MWO 9-2320-273-20-1

# MODIFICATION WORK ORDER

TRUCK TRACTOR, LINE HAUL, 50,000 GVWR, 6 X 4, M915 (NSN 2320-01428-4395)

- 1. PURPOSE. This modification consists of procedures to add a new air tank to the compressed air system.
- 2. PRIORITY. This modification is classified NORMAL.

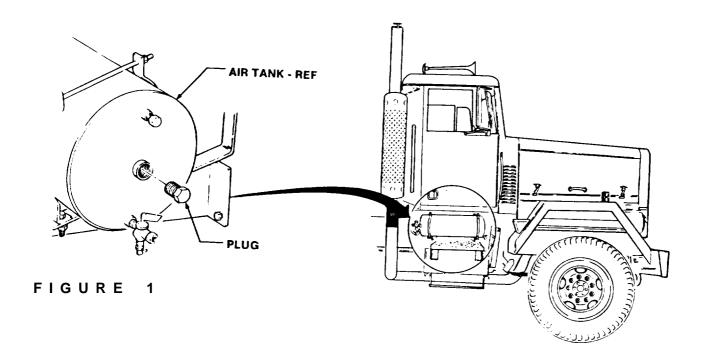
- a. Vehicle Preparation. (M915).
  - (1) Drain air system (refer to TM 9-2320-273-10).
  - (2) Remove plug from front of air tank as shown in figure 1.

FIGURE 2

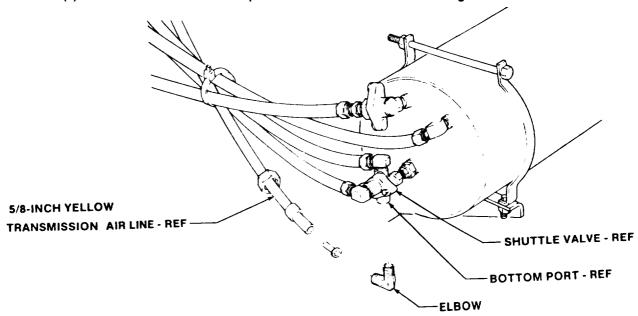
- (3) Remove 5/8-inch yellow transmission air line from elbow on shuttle valve as shown in figure 2.
  - (4) Remove elbow from bottom port on shuttle valve as shown in figure 2.

FIGURE 3

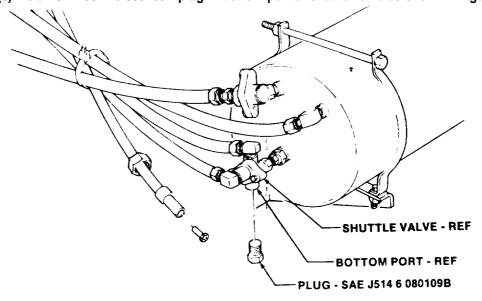
(5) Install SAE J514 6 080109B plug in bottom port of shuttle valve as shown in figure 3.

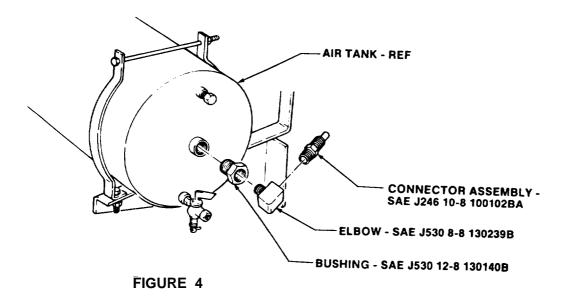
- (6) Install SAE J530 12-8 130140B bushing in air tank as shown in figure 4.
- (7) Install SAE J530 8-8 130239B elbow in bushing on air tank as shown in figure 4.
- (8) Install SAE J246 10-8 ltM102BA connector assembly to elbow as shown in figure 4. Retain sleeve and nut for use in 10. b. (8).

FIGURE 5

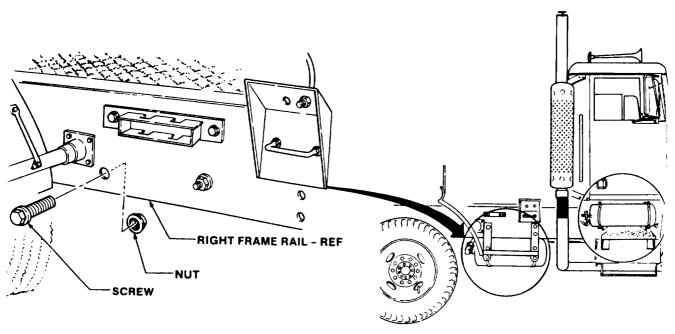
(9) Remove screw and nut from right frame rail as shown in figure 5.

FIGURE 6

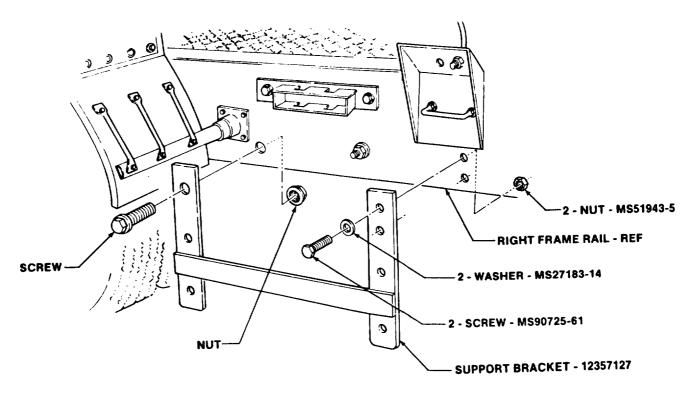
- (10) Install 12357127 support bracket to right frame rail and secure with two MS90725-61 screws, MS27183-14 washers, and MS51943-5 nuts as shown in figure 6. Tighten nuts finger tight.
- (11) Install screw (removed instep 9) through support bracket and right frame rail and secure with nut (removed in step 9) as shown in figure 6. Tighten nut finger tight.
  - (12) Tighten two screws installed in step (10) to 20 lb ft (40.7 N.m).
  - (13) Tighten screw installed in step (11) to 95 lb ft (128.8 N.m).

FIGURE 8

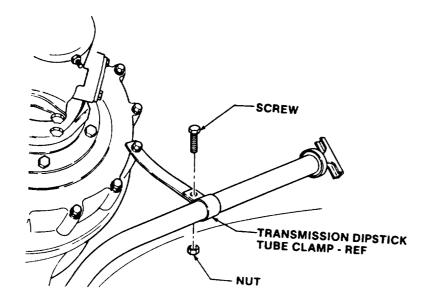
(15) Remove screw and nut from transmission dipstick tube clamp as shown in figure 8.

FIGURE 10

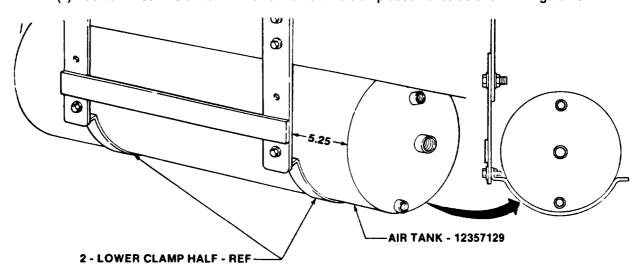
When installing air tank on clamp, ensure air tank is positioned as shown in figure 10.

(1) Position 12357129 air tank in lower half of two clamp assemblies as shown in figure 10.

FIGURE 13

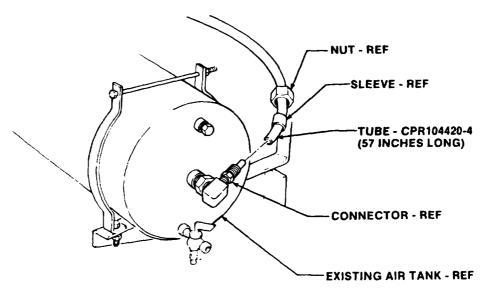
(8) Install CPR104420-4 (57 inches long) tube to connector on front of existing air tank and secure with sleeve and nut as shown in figure 13. Sleeve and nut retained from 10. a. (8).

FIGURE 15

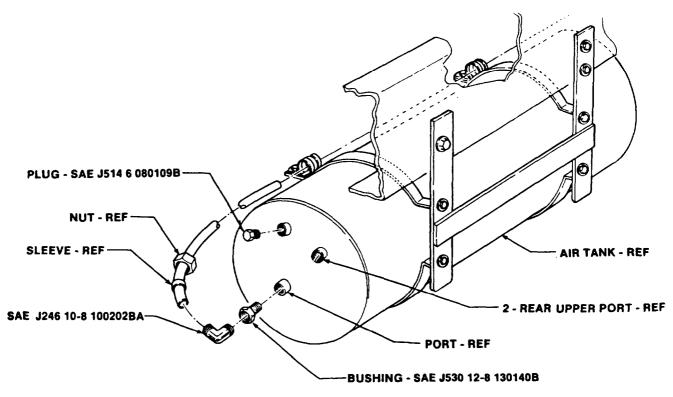
- (12) Install two SAE J5146080109B plugs in rear upper ports on air tank as shown in figure 15.
- (13) Install SAE J530 12-8130140B bushing in port on rear of air tank as shown in figure 15.

After installing elbow, ensure elbow in positioned as shown in figure 15.

(14) Install SAE J246 10-8 100202BA elbow assembly in bushing on air tank as shown in figure 15. Retain sleeve and nut for use in step 18.

FIGURE 2

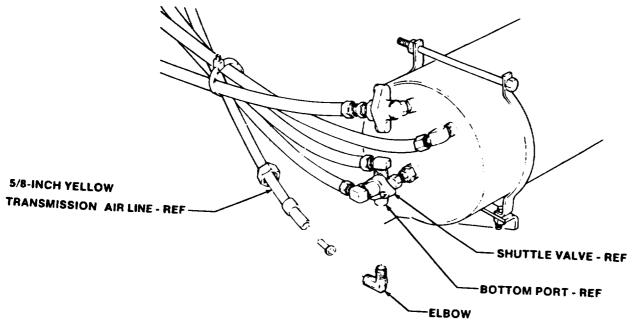
(3) Remove 5/8-inch yellow transmission air line from elbow on shuttle valve as shown in figure 2.

(4) Remove elbow from bottom port on shuttle valve as shown in figure 2.

FIGURE 3

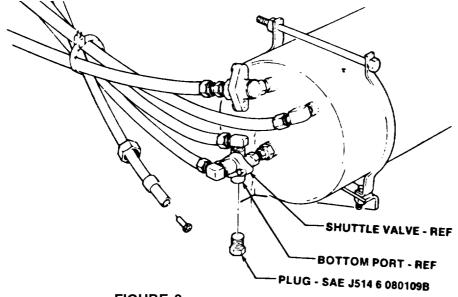
(5) Install SAE J514 6080109B plug in bottom port of shuttle valve as shown in figure 3.

FIGURE 4

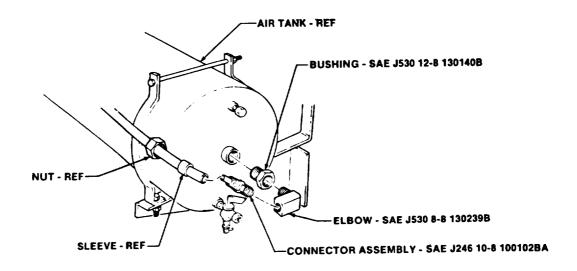
- (6) Install SAE J530 12-8 130140B bushing in air tank as shown in figure 4.
- (7) Install SAE J530 8-8 130239B elbow in bushing on air tank as shown in figure 4.
- (8) Install SAE J246 10-8 100102BA connector assembly in elbow as shown in figure 4. Retain sleeve and nut for use in paragraph b. step 8.

FIGURE 7

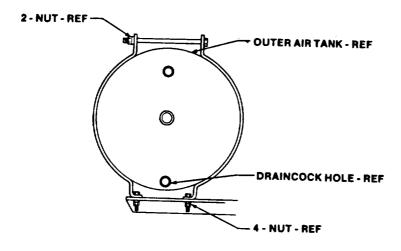
When installing the air tank on the supports, ensure it is positioned as shown in figure 7.

FIGURE 8

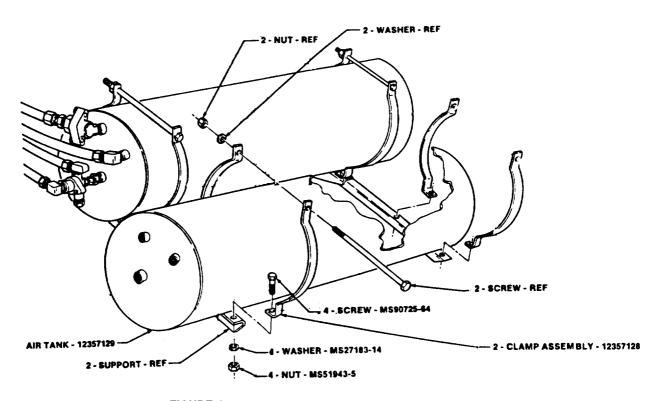
- (1) Install 12357129 air tank and two 12357128 clamp assemblies to two supports and secure with four MS90725-64 screws, MS27183-14 washers, and MS51943-5 nuts as shown in figure 8. Tighten nuts finger tight.
- (2) Install two screws through two clamps and secure with two washers and nuts as shown in figure 8. Tighten nuts finger tight.
- (3) Ensure outer air tank is positioned as shown in figure 7 and secure nuts installed in steps 1 and 2.

FIGURE 9

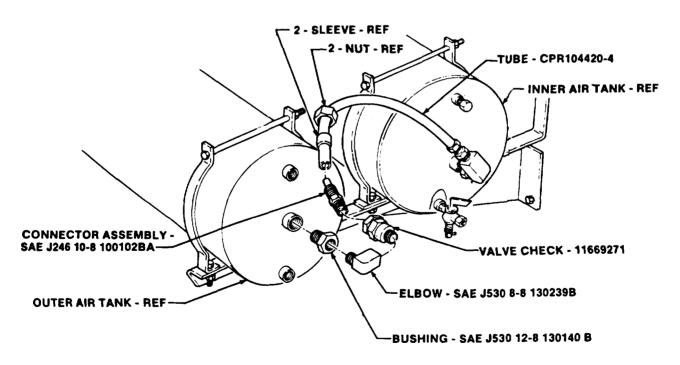
- (4) Install SAE J530 12-8 130140B bushing in forward end of outer air tank as shown in figure 9.
- (5) Install SAE J530 8-8 130239B elbow in bushing on outer air tank as shown in figure 9.
- (6) Install 11669271 check valve in elbow on outer air tank as shown in figure 9.
- (7) Install SAE J246 10-8 100102BA connector assembly in check valve on outer air tank as shown in figure 9. Retain sleeve and nut for use in step 8.

(8) Install CPRI044204 tube to inner and outer air tanks and secure with two sleeves and nuts as shown in figure 9.

FIGURE 10

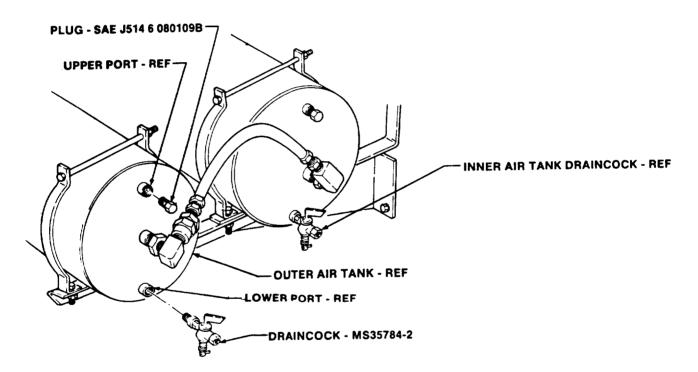
- (9) Install SAE J514 6 O8O1O9B plug in upper port on outer air tank as shown in figure 10.
- (10) Install MS35784-2 draincock in lower port on outer air tank as shown in figure 10.

FIGURE 12

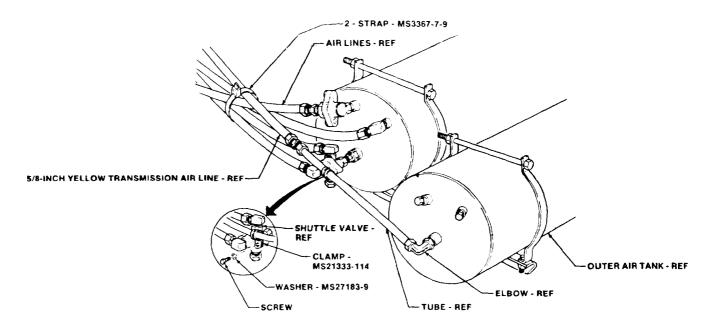
- (18) Remove screw from shuttle valve and install MS21333-114 clamp around tube and secure tube to shuttle valve with screw and MS27183-9 washer as shown in figure 12.
- (19) Secure 5/8-inch yellow transmission air line to air lines with MS3367-7-9 strap as shown in figure 12.
